E6393A-02

S E R V I C E N O T E

Agilent Technologies E6393A CDMA MS Test Set

The wrong jumper setting causes Printer Port failure

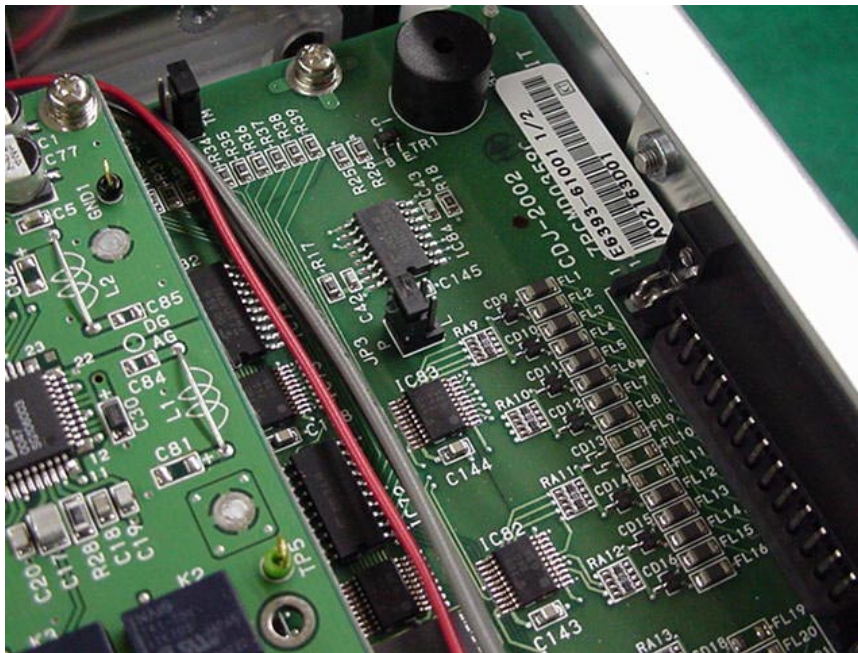
It has been found that some E6393A with the wrong jumper setting on A1 Management Processor Circuit was shipped. This wrong jumper setting causes the printer port failure. The printer port failures are as follows.

1. Open the instrument cover referring to the Parts Replacement section of the E6393A Assembly Level Repair Manual.
2. Find the jumper “JP3” on the A1 Management Processor Circuit. It is located near the printer port connector, and between the IC83 and the IC84. See the picture below.

3. Check if the jumper is inserted to position “P”. If it is inserted to position “L”, move the jumper to position “P”.
4. Check the E6393A can print out to the printer.
5. Replace the instrument cover.
